QUESTION & ANSWER ACKNOWLEDGEMENT FORM

Proposal No: RFI 2019-04
Proposal Title: Wireless Infrastructure Modernization Project
Proposal Due Date: May 31, 2019 @ 1:45 p.m. EDST
Proposal Opening: May 31, 2019 @ 2:00 p.m. EDST
Date: May 14, 2019

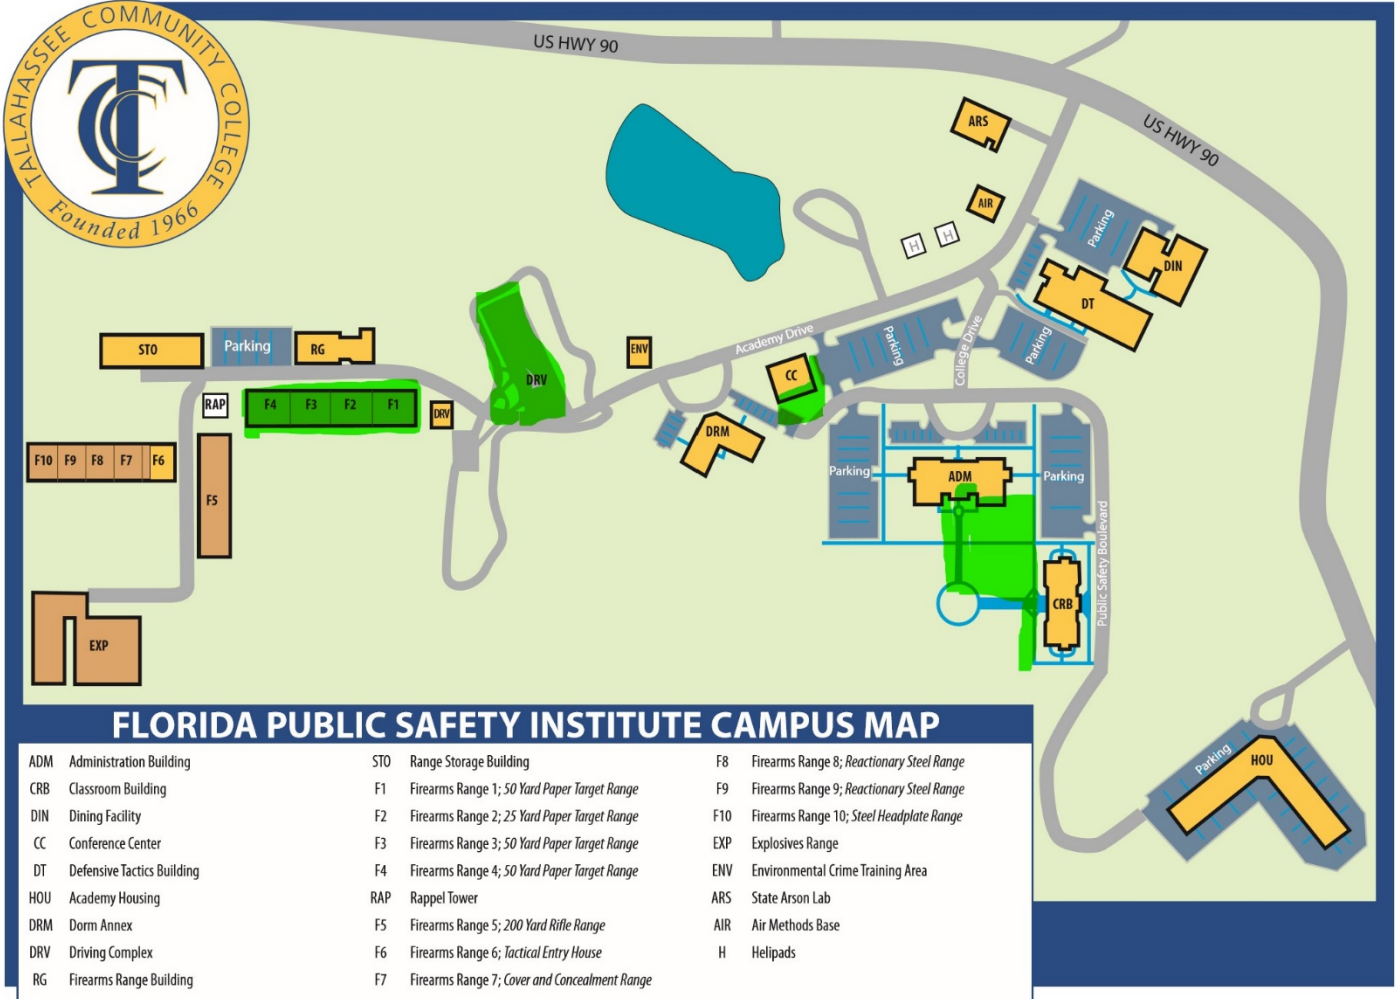
Question #11	11. Are any APs mounted outdoors? Some maps seem to indicate APs outside a) If outdoor APs are required, can the district confirm the mounting surfaces for those APs and antenna patterns required? (omnidirectional, directional, etc)

Answer #11	11 There are some locations on main campus that have external antennae. See "Appendix A" below this document. 11a) This depends on the suggested implementation from the vendor.

**FACILITY #1 (GCHE)
GHAZVINI CENTER FOR HEALTHCARE
EDUCATION
1ST FLOOR PLAN**

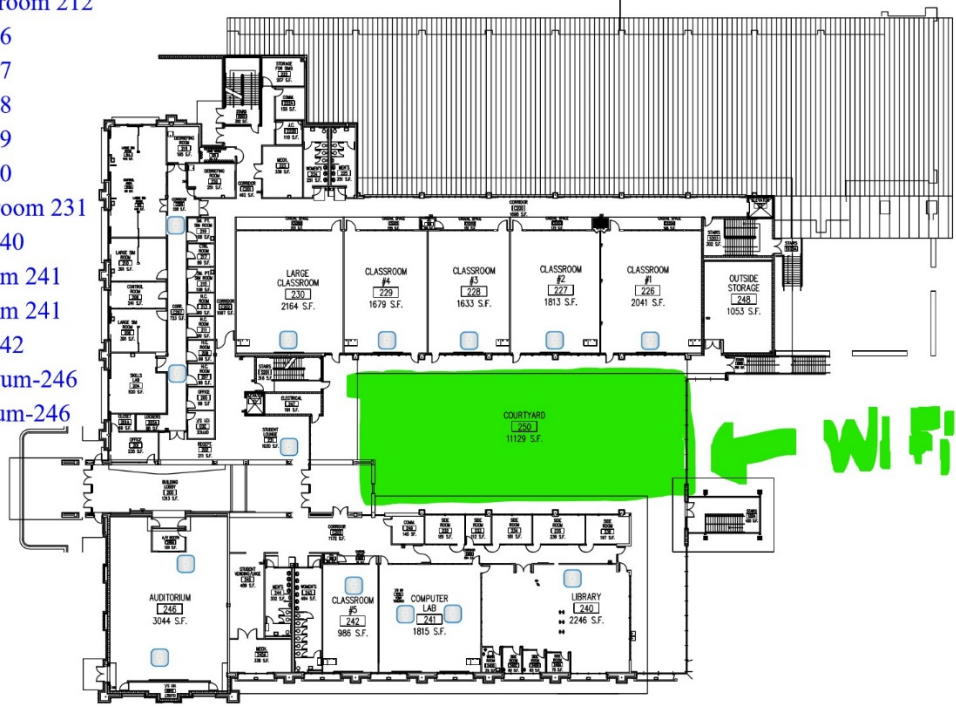
Question #27	Is there any location that you expect outdoor coverage?
Answer #27	While we do wish to have outdoor coverage, there are specific areas, especially on the Main Campus, Florida Public Safety Institute and Ghazvini Center for Healthcare Education campus that require outdoor coverage. Please see Appendix B below this document.

- AP - Inside reception room 100
- AP - Hallway outside room 121
- AP - Hallway outside room 127
- AP - Hallway outside room 131
